AMENDMENT OF SOLICITATION/MODIFICATION OF CONTRACT			1. CONTRACT ID CODE		PAGE OF PAGES 1 5		
2. MODIFICATION NO.: 0007		3. EFFECTIVE DATE JUN 16, 2005		4. REQUISITION/PURCHASE REQ. NO. W81W3G-2035-7181		PROJECT NO. (If applicable)	
6. ISSUED BY Department of the Army Baltimore District, Corps of Engineers Contracting Division P.O. Box 1715 Baltimore MD 21203-1715		CODE CA31		7. ADMINISTERED BY: Contracting Division, Contracts Branch CENAB-CT-C 10 S. Howard ST. Room 7000 Baltimore, MD 21203-1715		CODE E1P0100	
8. NAME AND ADDRESS OF CONTRACTOR (No., street, county, State and ZIP Code)				(x)		9A. AMENDMENT OF SOLICITATION NO. W912DR-05-R-0052	
				X		9B. DATED (SEE ITEM 11) MAY 18, 2005	
						10A. MODIFICATION OF CONTRACT/ ORDER NO.	
						10B. DATED (SEE ITEM 13)	
CODE		FACILITY CODE

**BARRACKS COMPLEX, PHASE 1
FORT MYER, VIRGINIA**

AMENDMENT NO. 0007 TO RFP W912DR-05-R-0052
EFFECTIVE JUN 16, 2005

SK-M-1

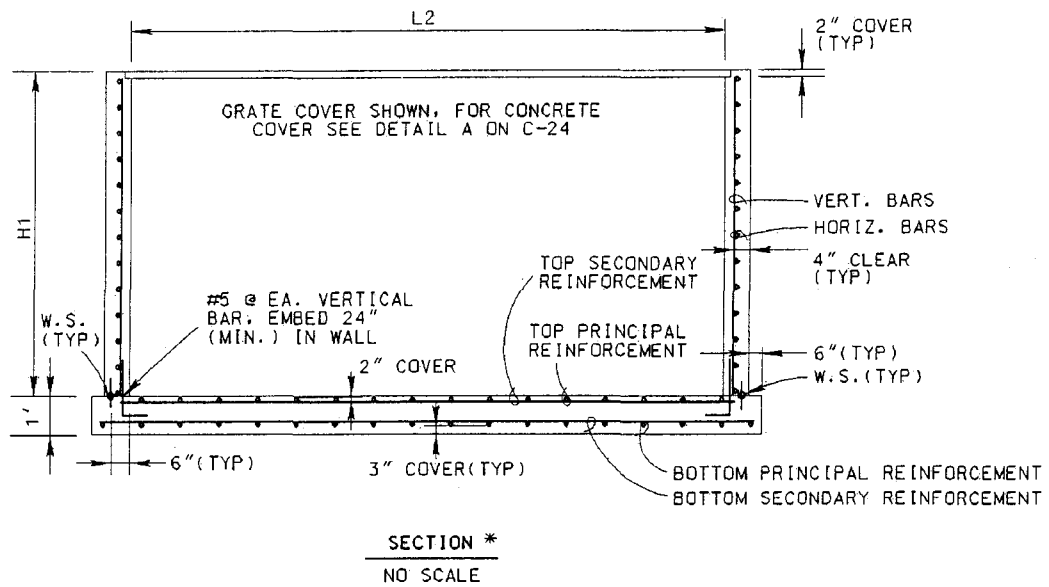
- 22) Sheet M502, Chilled Water Distribution System Manhole Details:
- a. Delete the 14' dimension and substitute 13' dimension.
 - b. Delete the 16' dimension and substitute 15' dimension.
- 23) Sheet M504: Add attached Sketch SK-M-1, dated June 16, 2005.
- 24) Sheet M504: Add attached Sketch SK-M-2, dated June 16, 2005.
- 25) Sheet MI602: Delete this sheet in it's entirety as originally issued and substitute the attached revised like-numbered sheet, dated Jun 10 2005.
- 26) Sheet M605, Pump Schedule:
- a. Add the following note in the "Remarks" column next to P-12 and P-13:
"SEE NOTE 1".
 - b. Add the following note below the pump schedule: "NOTE 1: MAXIMUM REQUIRED NET POSITIVE SUCTION HEAD FOR PUMP SHALL BE 5 FT. HEAD."

Question: Please provide a rebar design for the CIP Steam Manhole shown in detail AA/M504. Please include any necessary reinforcement at mechanical penetrations, manway openings and support beam anchorage. Spec sections 03300 and 03300A offer criteria but no design for rebar.

NOTES: SEE TABLE FOR REINFORCEMENT BAR SIZES.

Valve Manhole Plan and Section.
